## SAFETY ADVISORY # 17-285

### Voltage Generator Fuel Line

**Models Included:** 2017-2018 Voltage Models with Onan 5.5 Generator Option

**Fig. 3**

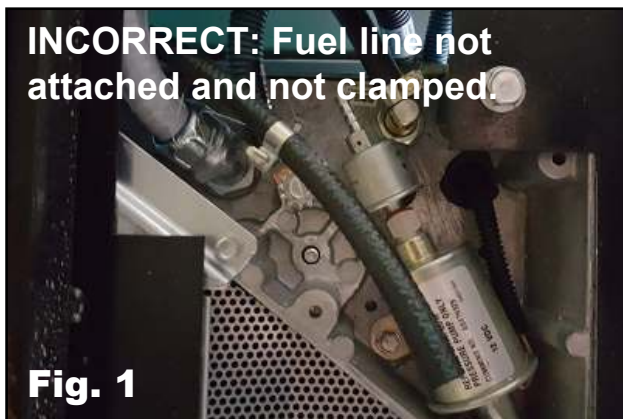
Look under the generator and inspect the incoming fuel line and clamp to the generator where the line attaches to the fuel filter. Verify the fuel line is fully engaged on the barb fitting and the clamp is in the proper position and it is tight. Incorrect installation Figures 1 & 2. See Figure 3 for correct installation.
